Ref: 24ADL-0313

## Variation to Application ID 24029287 – Buckingham Arms

This letter outlines the proposed variations to DA 24029287. An assessment of the variations is also provided below.

**Figure 1: Proposed variation – single level terrace apartment 008 removed, swimming pool plant room now located in place of apartment.**

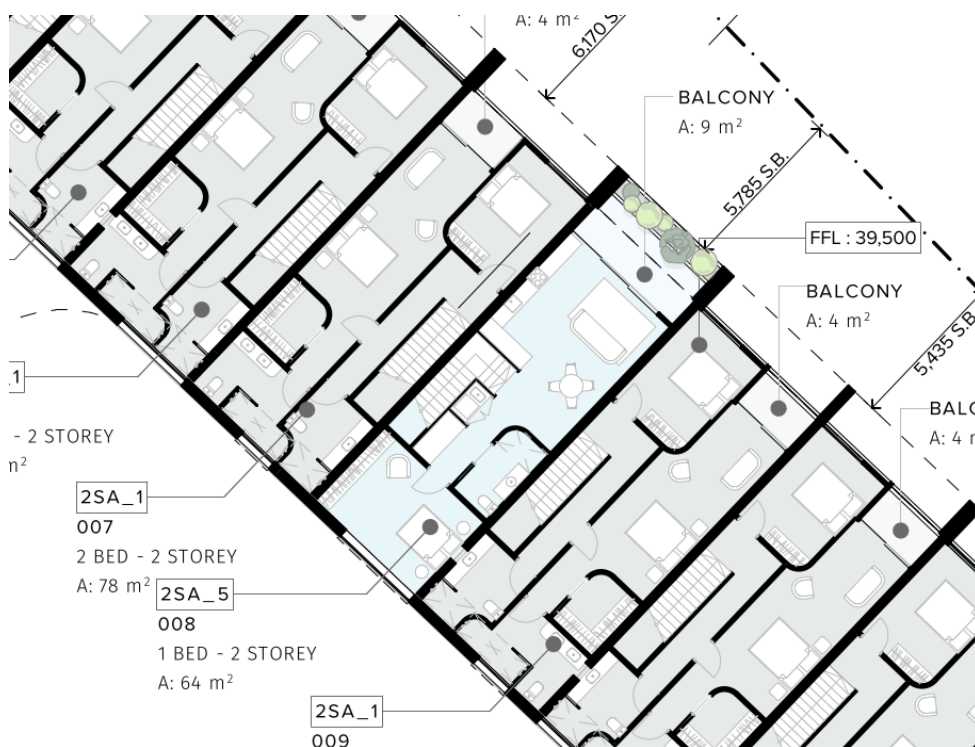
The terrace apartment (townhouse) referred to as 008 on the original planning consent has been removed. The plant equipment for the swimming pool located above is now located in the space previously occupied by terrace apartment 008. Refer **Figures 1 and 2** below.

Privacy treatments have been applied to balconies internal to the site which face each other and to the north east facing balconies of apartments 307 (previously 308) and 405 and 406 (previously 406).

Reserved Matter 5 is therefore satisfied.
